Technical Information Notice

Title: Own	I-02-2018	Revision No.	.: 1	Is	sue Date: 01/0	3/2018		
	ers Service Bul	lletin – OSB	31 Issue 2					
Applicability:	Ikarus C42A &	B models w	ith A-strut pa	assing thro	ough main fusel	age tube		
Information Type(s): MANDATORY								
Modification:		Airworthine MPD	Airworthiness / MPD		Maintenance / Operation			
Parts:		Inspection	Inspection		Other			
Importance:	ESSENTIAL	✓	HIGH		ROUTINE	~		
An aircraft with severe cracking of the main fuselage tube emanating from the upper cut-out for the A-strut was also found to have suffered severe cracking of the A-strut around its entire circumference, this is no longer an isolated occurrence after three have now been found in the UK, they have all been high hours (circa 4000) but not all involved in an accident. This was hidden within the outer sleeve positioned at the connection between the A-strut and the upper surface of the main fuselage tube. The load path was maintained by the single small rivet used to locate the outer sleeve on the A-strut. See Figures 1 & 2. It is believed that the cracking was a result of excessive loads placed upon the A-strut due to the near-failure of the main fuselage tu

Figure 4 - endoscope in operation

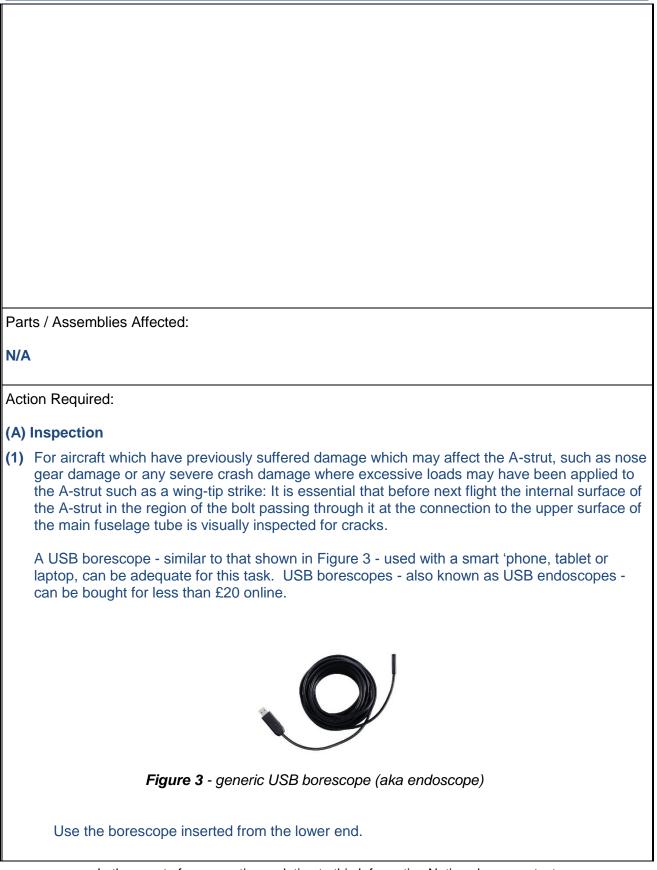
Figure 4 shows an endoscope being used to inspect a C42 front strut. The area of interest is approximately 200mm up the front strut.
